**RE: MOT-35-18.18, PID 80277, SJN 478433; NPDES Permit #1GC04473*AG;
Compliance Inspection Findings**

Ohio EPA DSW Storm Water Section, Construction Site Visit Information Form

Site Name: MOT-35-18.18, PID 80277, SJN 478483

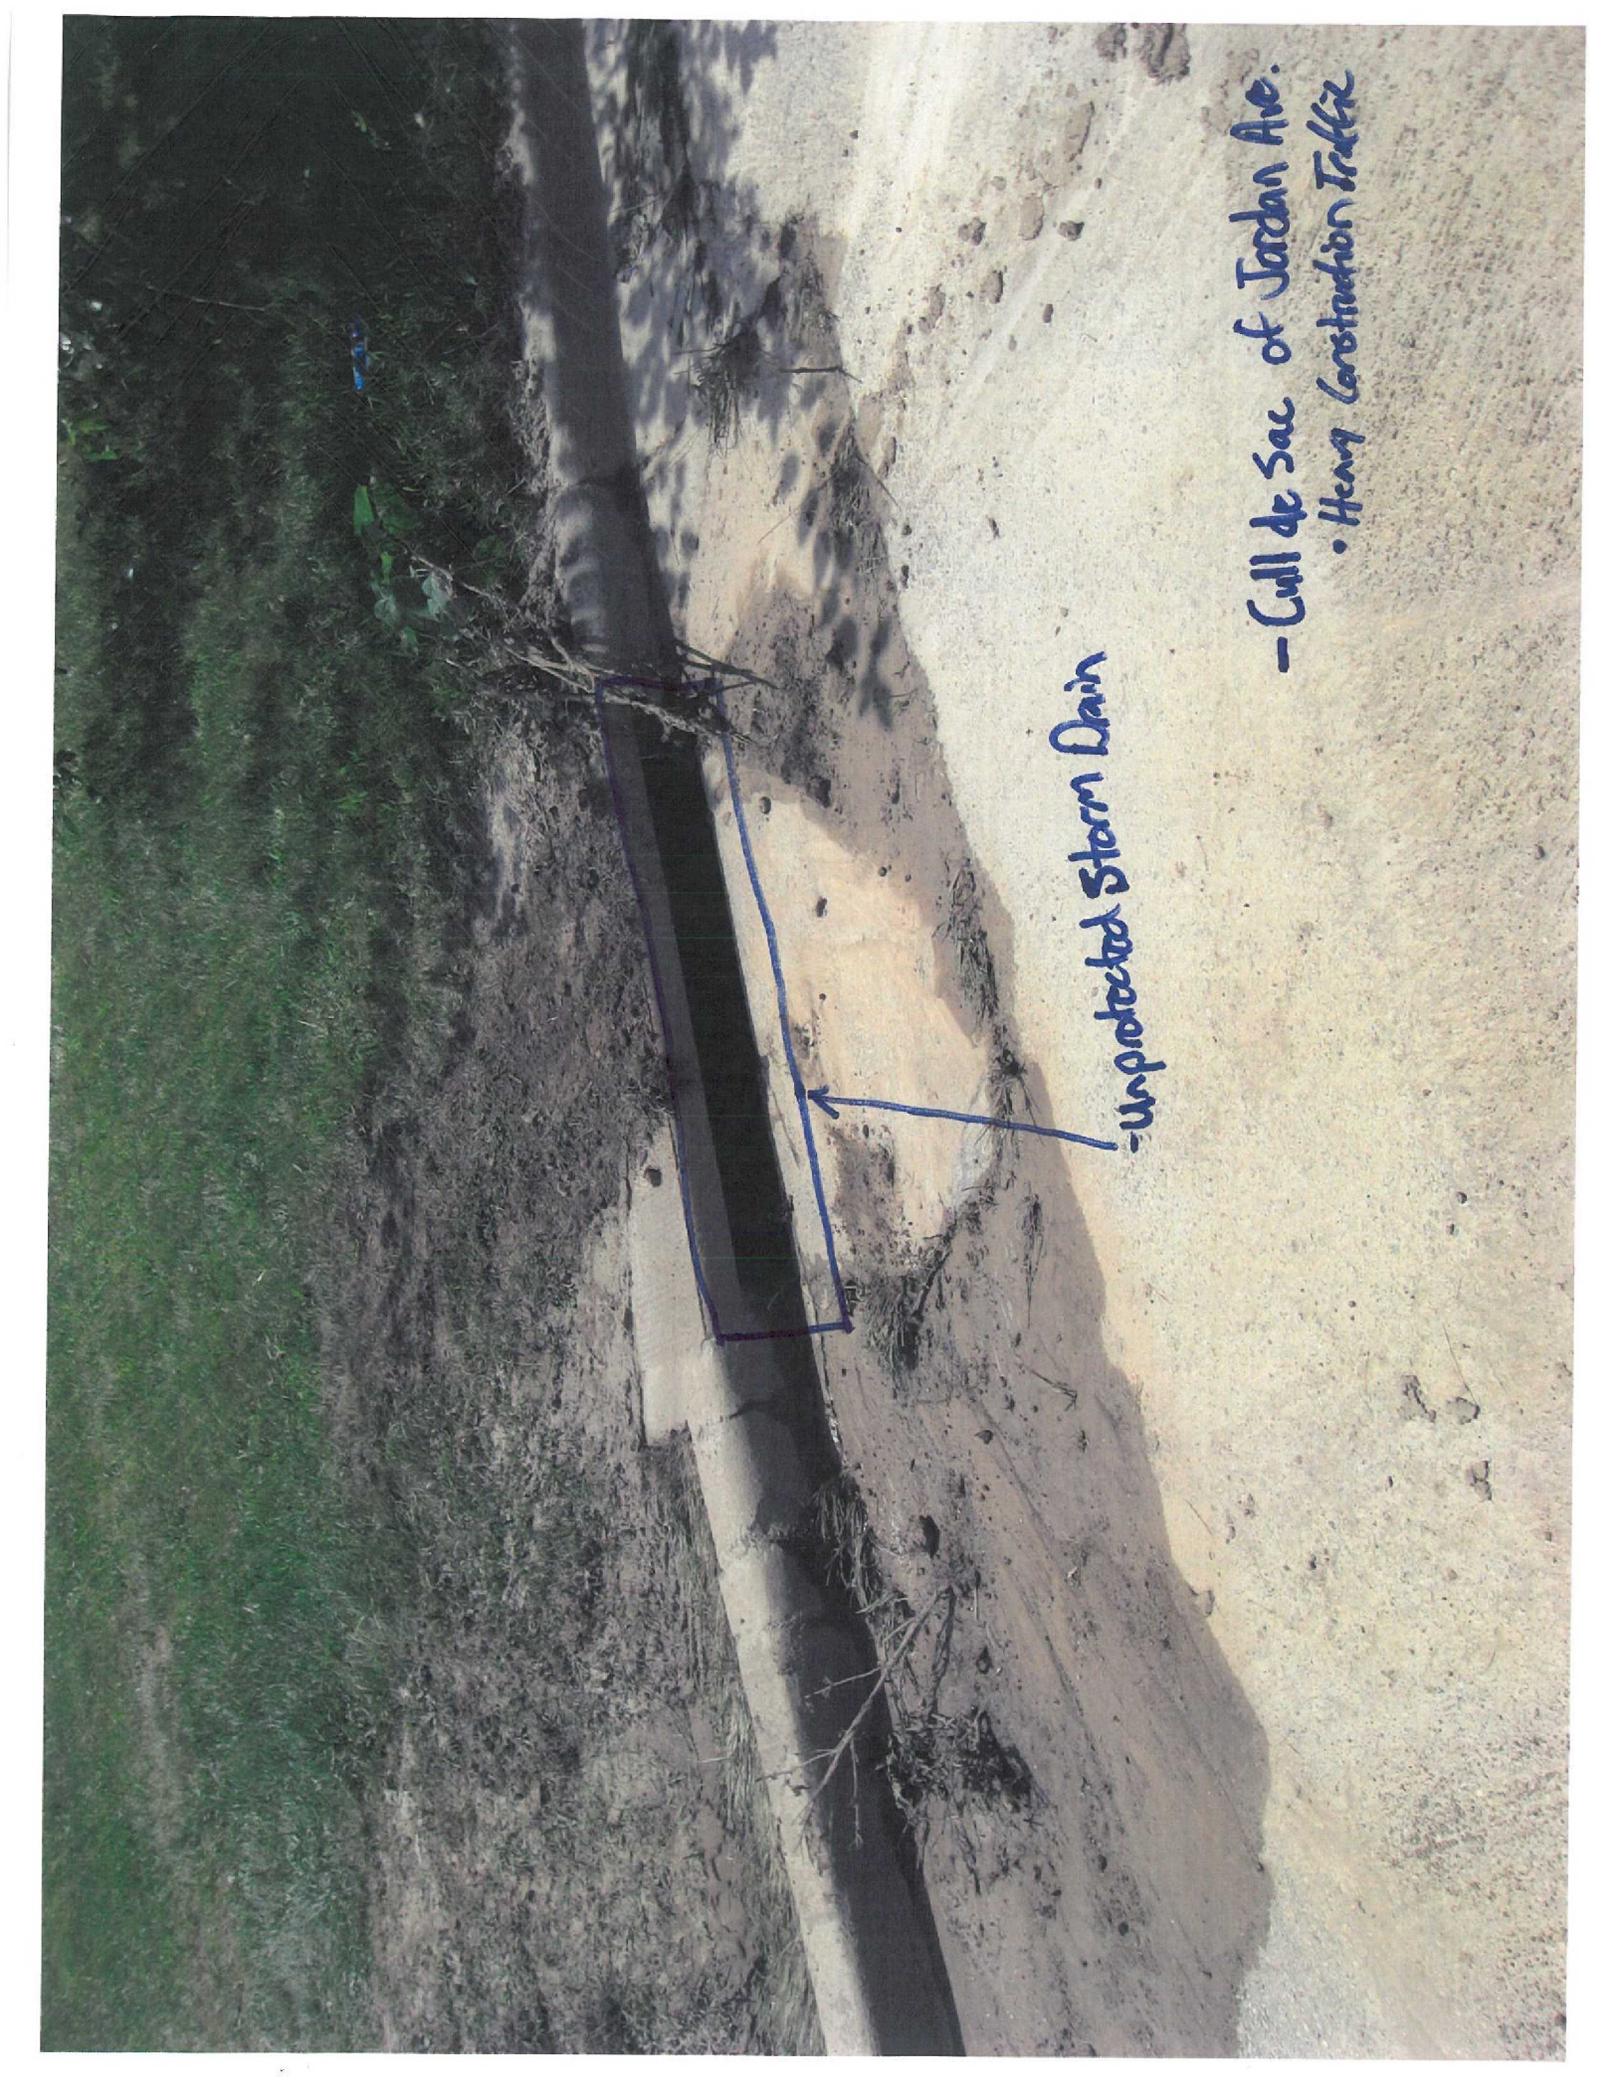
-unprotected Storm Drain

- Cull de Sac of Jordan Ave.
• Heavy Construction Traffic

Additional notes/comments:
 - Minimal Disturbance (Noise wall along US Route 35)
 - Stabilize when necessary
 - Erosion controls on steep embankments
 - Storm Drain Inlet protection (Maintain + Install Dandy Bags on side streets)
